MODIFICATION REQUEST:

26 Broadway, Chippendale

***MP 08_0253 MOD 3 – Modification to the
approved central thermal plant***

Director-General's
Environmental Assessment Report
Section 75W of the
Environmental Planning and Assessment Act 1979

Figure 2 shows the CTP (Stage 1) in context of the existing basement component to Blocks 1 and 4 (Stage 2).

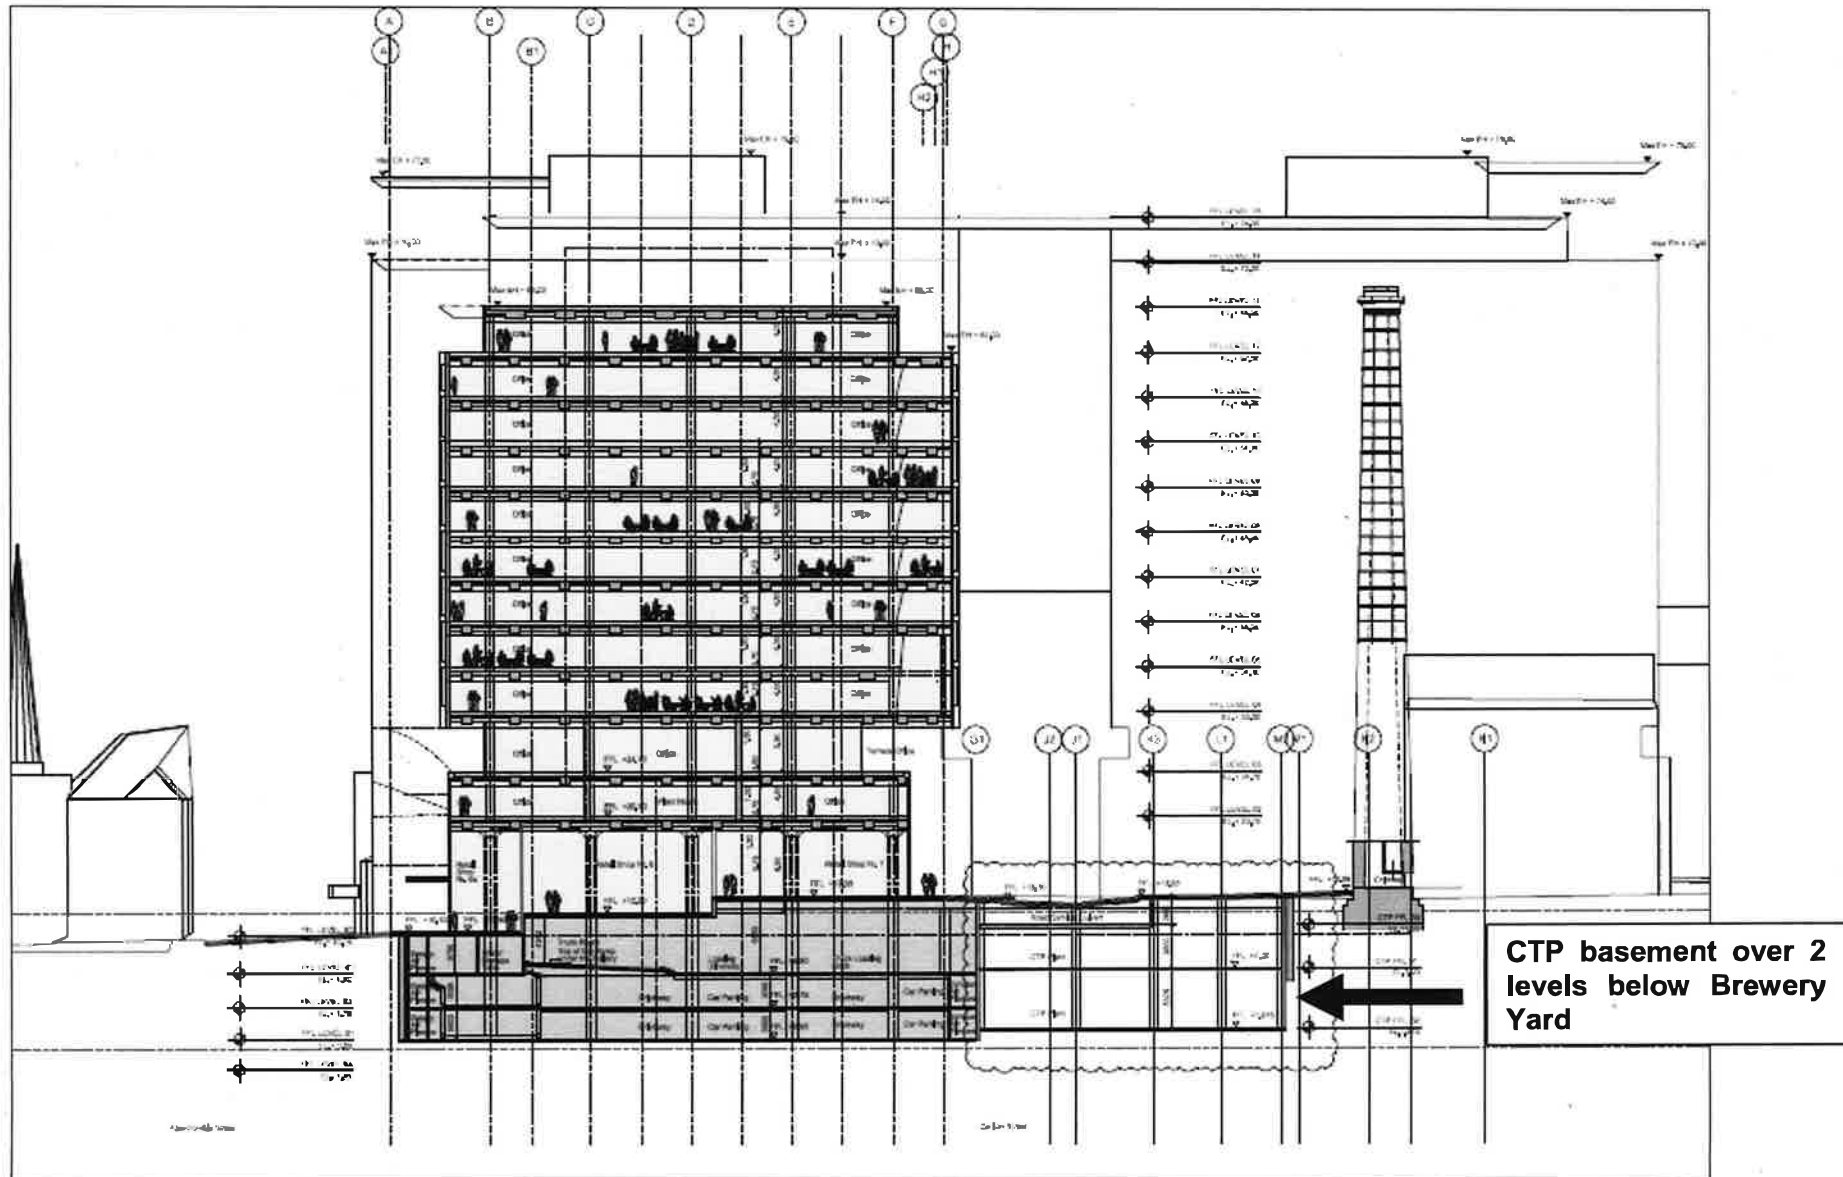
The scope of works for Stage 1 reduces the size of the CTP basement structure by removing the tri-generation plant, including thermal storage, and reducing the previously modified depth from 4 to 2 levels. In effect, the proposed modification reduces the tri-generation plant production to a single 1.0MWe co-generation gas engine. Stage 2 comprises the remainder of works to Blocks 1 and 4.

The proponent has advised that the capacity within the CTP basement is sufficient to accommodate 2 x 1.0MWe co-generation gas engines. Notwithstanding, the final size of the CTP facility (either co-generation or tri-generation mode) is the subject of discussions currently underway with potential operators and will be confirmed in Stage 2. The Department therefore recommends that the final details for installing the tri-generation equipment be provided prior to the release of the Construction Certificate for Stage 2. An appropriate condition of approval is therefore recommended (Condition A13).

On this basis, the Department is supportive of staged construction to expedite delivery and operation of the co-generation facility ahead of the remainder of Blocks 1 and 4.
